Type Coffee Vending Machine	Model 9100 - 9200	N° T.I. 11 - 2019	
Serial Number 93110336	Subject NEW DRIP TRAY PLASTIC PROFILE	ISSUED FOR (X)	Action Information X

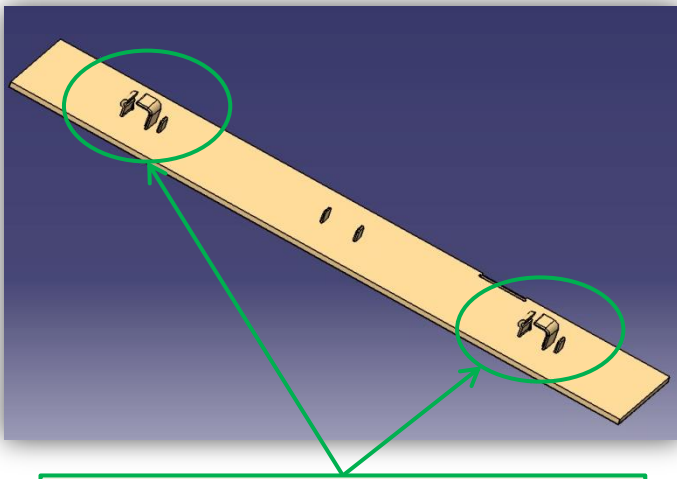
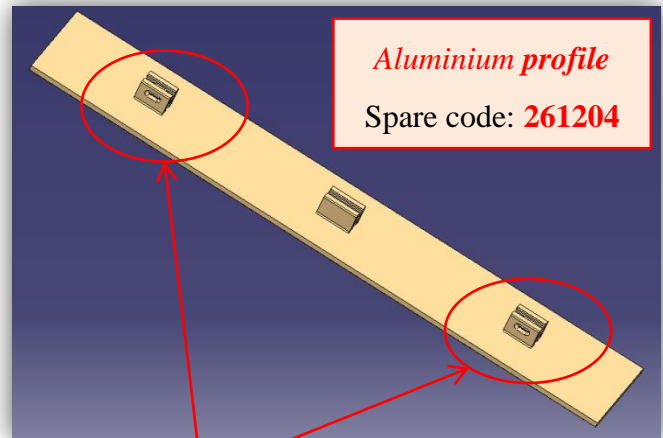
The *aluminium* drip tray profile has been replaced by a *plastic* profile

Clips included in the new molded profile

For machines previous to above **S/N** it's possible to use **new plastic profile**, that replaces *aluminium profile* + *N.2 fastening clips*
